Re: Response to RFI dated 17/06/2024 in relation to *Submission of Addendum to the Sediment and Erosion Control Plan for Kings Forest (MP08_0194)* - Environmental Component

Our Reference: 12301-KFP2 [ID 1006370]
State Gov Reference: MP08_0194, DOC21/248960, 12/5212#69

**Re: Response to Information Request in relation to Submission of Addendum to the
Sediment and Erosion Control Plan for Kings Forest (MP08_0194)**

Plate 1: Location of proposed stormwater treatment system within approved Kings Forest Parkway road reserve

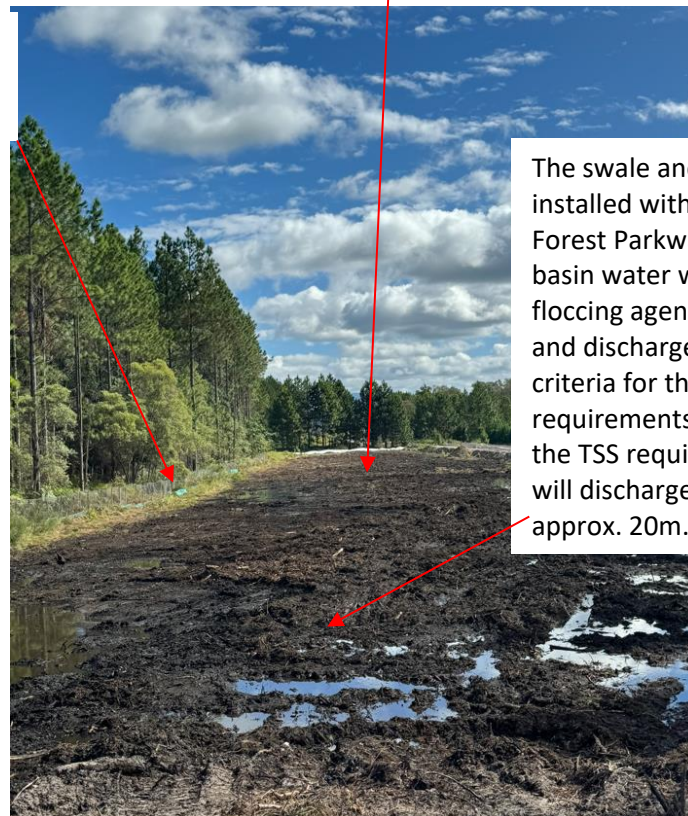
There will be at least 20m of flat grass before discharge reaches North-South drain.

Temporary koala fence with sediment fencing at base for WSF barrier

The swale and HES basin will be installed within the approved Kings Forest Parkway road reserve. The HES basin water will be treated with a floccing agent to meet TSS criteria and discharge will only occur if the criteria for the WSF water quality requirements are also met as well as the TSS requirements. Then the water will discharge over flat grass for approx. 20m.

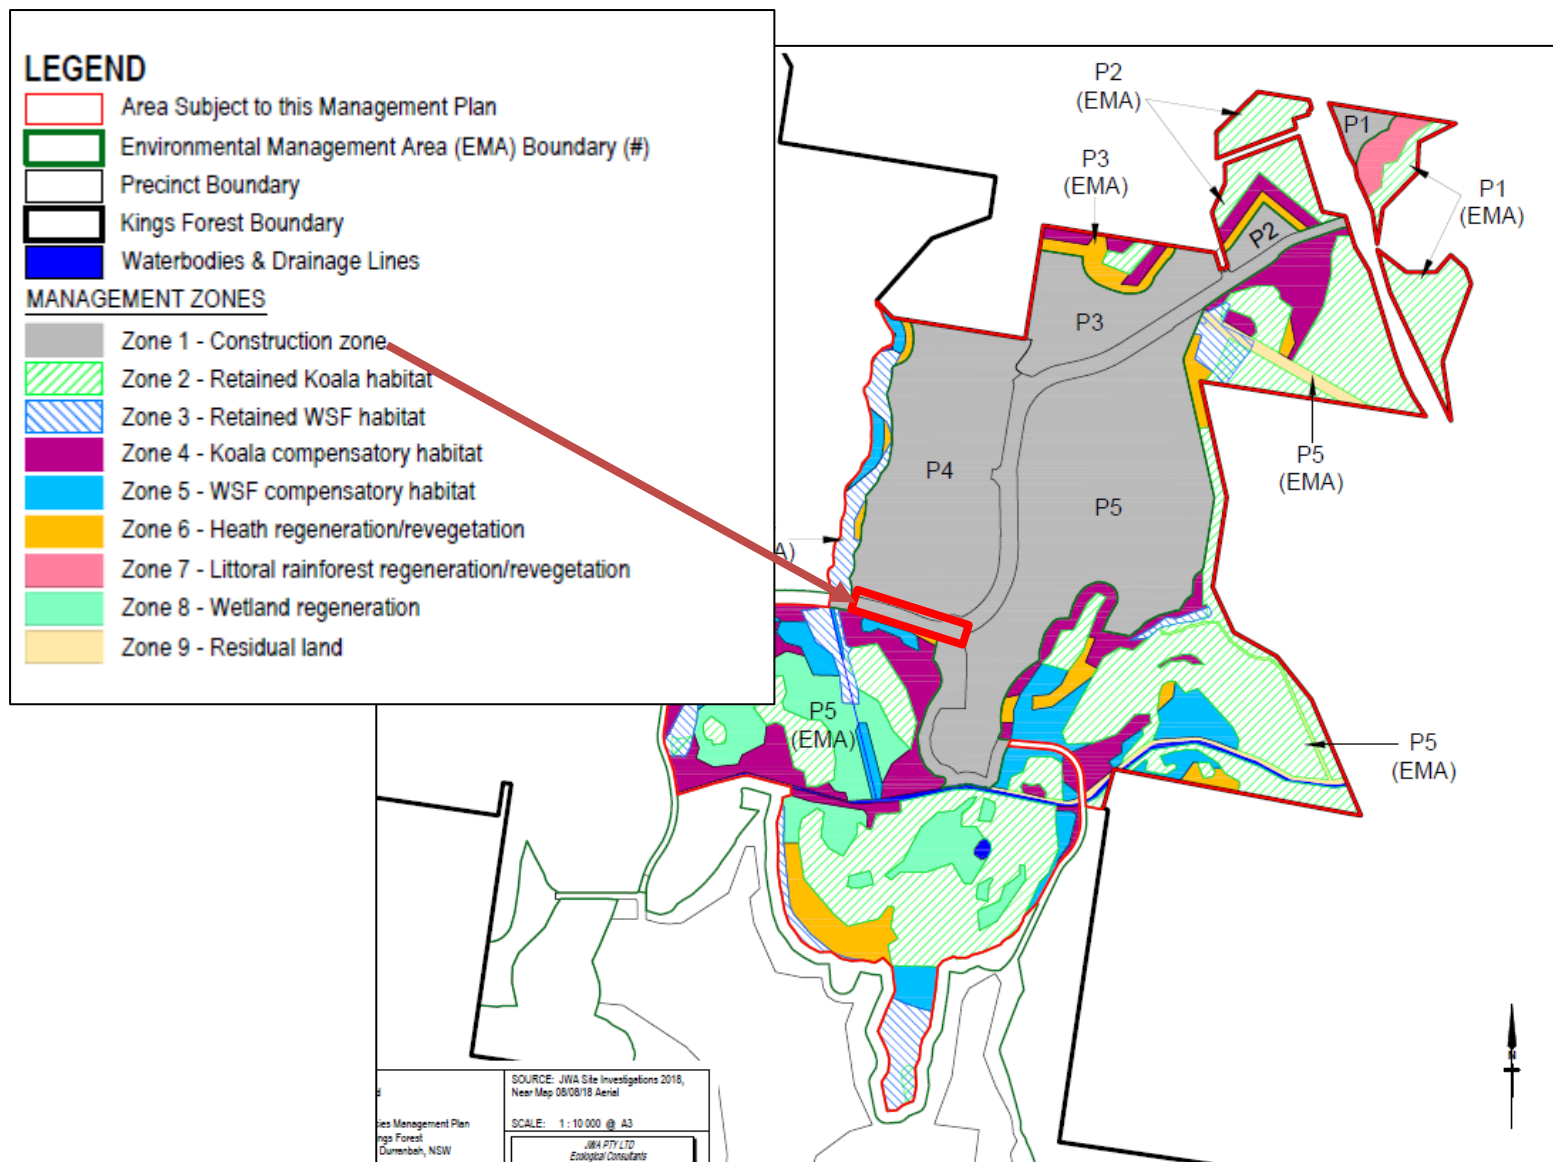
“The construction zone consists of the development footprint of Precincts 1 - 5. The development footprint also includes the 20 m outer buffer zone adjacent to Precinct 5 which will be utilised for stormwater conveyance and ancillary structures such as fauna exclusion fencing (FIGURE 20)”.

- The location of the proposed treatment system is confined to the area known as Zone 1 - Construction Zone in accordance with Figure 20 of the Threatened Species Management Plan (JWA 2021 (overleaf)). Works will be undertaken within the 20m outer buffer zone however as per the project approval MP08_0194 this is within the approved road reserve for Kings Forest Parkway.

Figure 1: Natural outlet structure

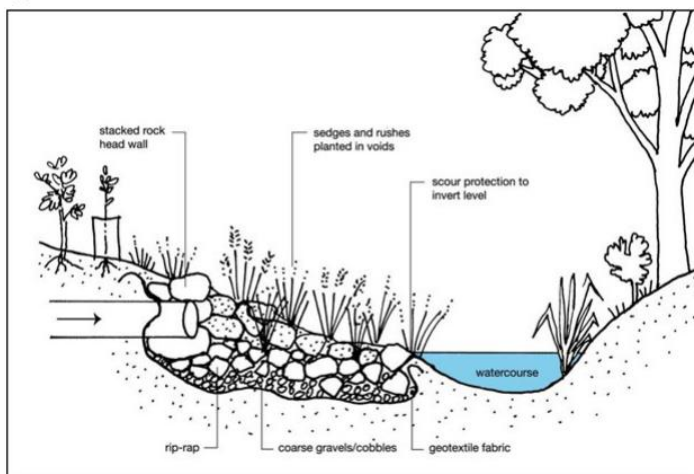
1. *Rip-rap should consist of durable, angular run-of-quarry rock placed over a bedding layer of angular cobbles over geotextile. Where possible, incorporate vegetation such as sedges and rushes into scour management as Figure 1 for further stability.*

As per above no structure is to outlet into a streambed or bank. The HES, the weir structure and the dissipator will allow water to leave the HES basin in a controlled manner across native ground prior to discharging in waterways downstream.
